GW - 1

Re: Discharge Permit renewal GW-01 request and;
Approval of North Boundary Barrier Collection Design and Monitoring Plan Phase II.

Subject: APPROVAL WITH CONDITIONS
NORTH BOUNDARY BARRIER COLLECTION SYSTEM DESIGN AND
MONITORING PLAN PHASE II
RCRA PERMIT NO. NMDD 089416416
HWB-GRCB-04-005

Re: Giant Bloomfield Refinery
North Boundary Barrier Collection System Design and Monitoring Plan

FIGURE 2

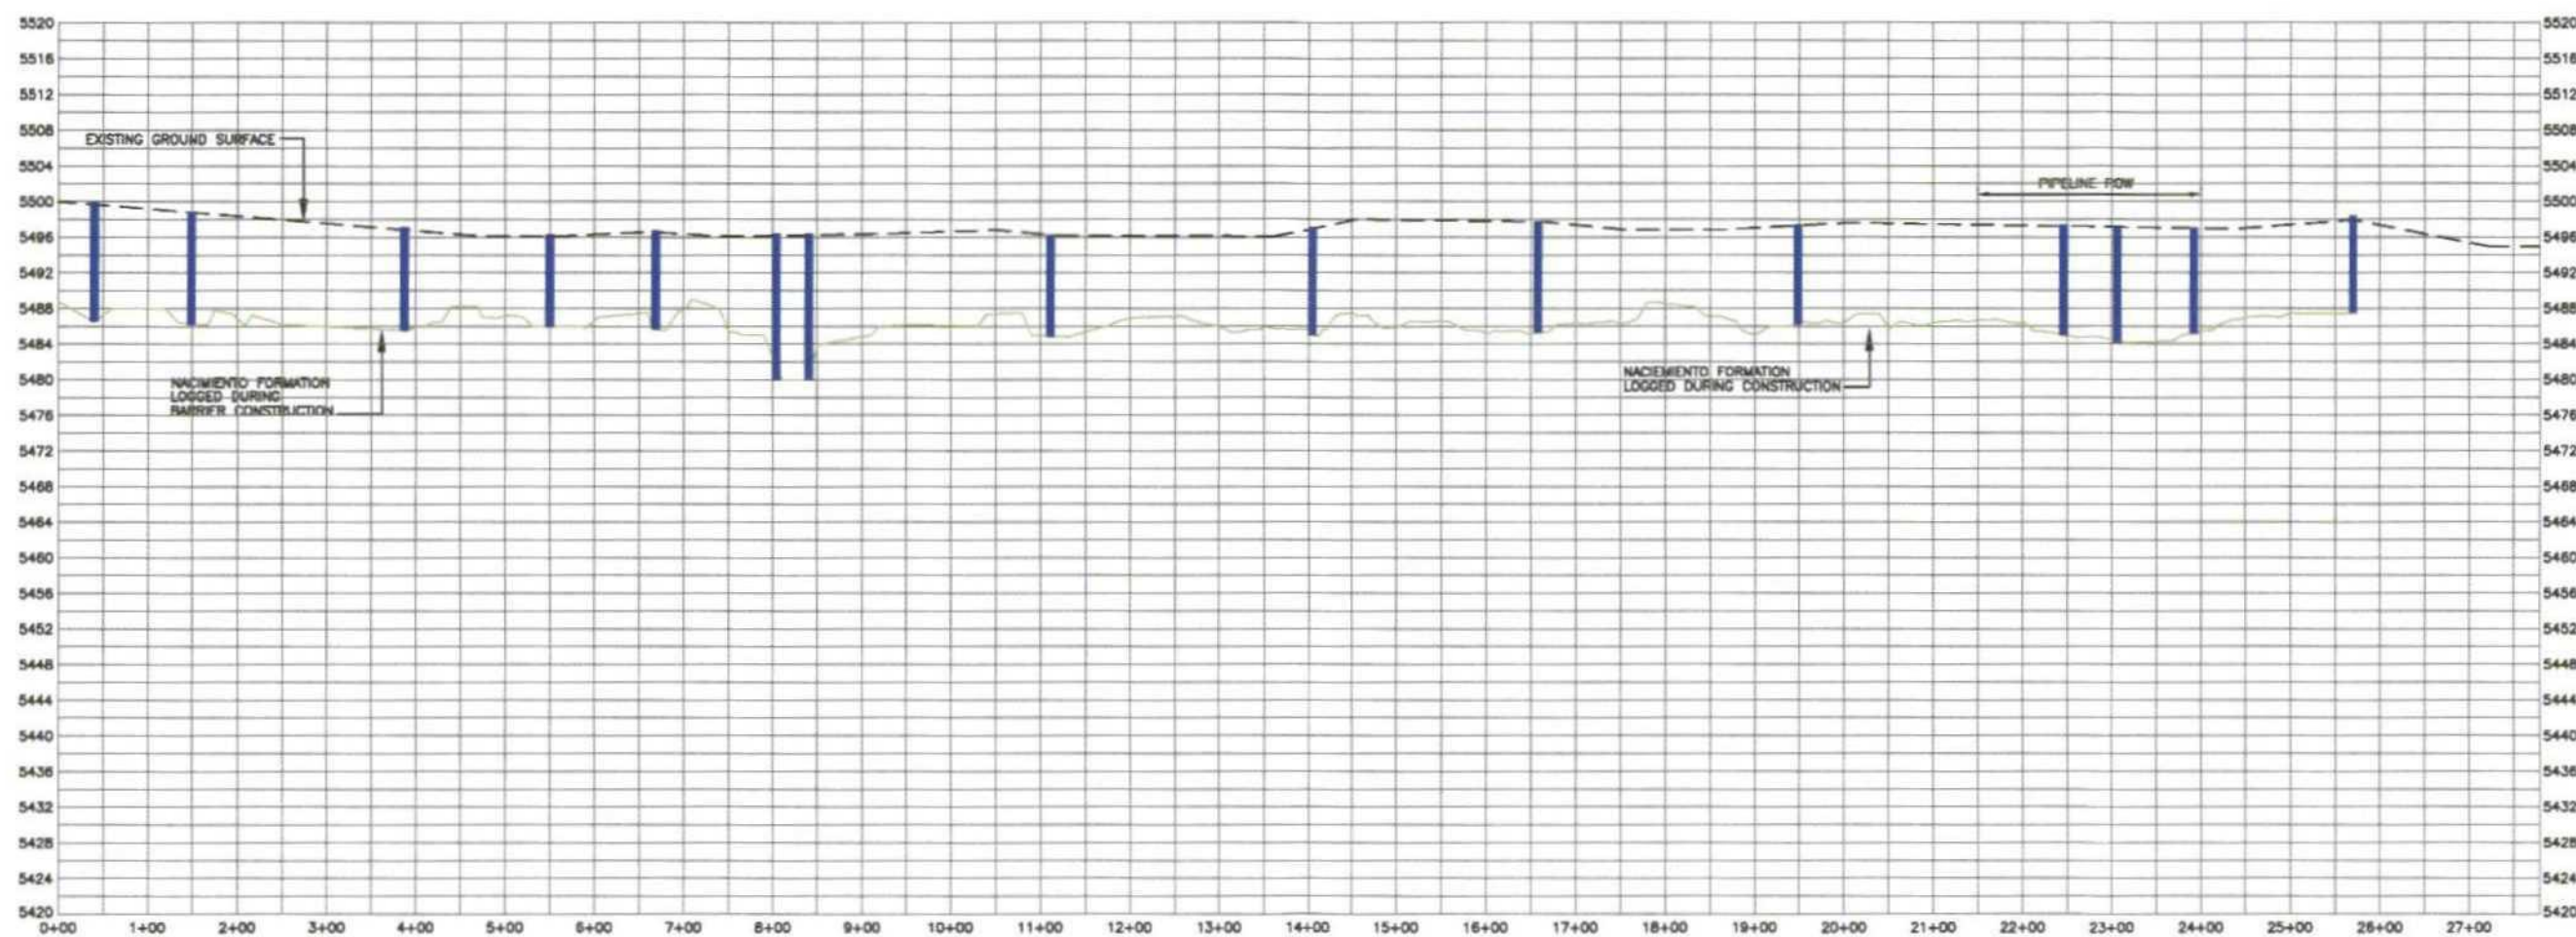
Giant Refining Company Bloomfield (GRCB) is submitting for your review and approval the attached two exhibits (Figures 2 and 3) depicting the locations of the collection and observation wells to be installed along the north boundary barrier at the Giant Refinery in Bloomfield, New Mexico. These exhibits include the Phase II wells described in the March 7, 2004 North Boundary Collection System Design and Monitoring Plan submitted to OCD.

The location of all collection wells, including the proposed location of the Phase II Collection wells along the eastern portion of the barrier, are shown on Figures 2 and 3. These figures supersede those included with the March 7, 2005 plan. The wells will be installed as described in the March 7, 2005 plan, with the exception that the filter pack design has changed as described above. The wells will be drilled into the Nacimiento formation and will be screened across the water table. Each collection well will have a corresponding observation well located on the river side of the barrier. Monitoring activities will follow the schedule outlined in the March 7, 2005 letter.

All wells will be installed as described in the March 7, 2005 plan, with the exception that the collection well filter pack has changed to a 8 X 12 Colorado silica sand from the 10 X 40 Colorado silica sand stated in the March 7, 2005 plan. All other aspects of the plan remain the same.
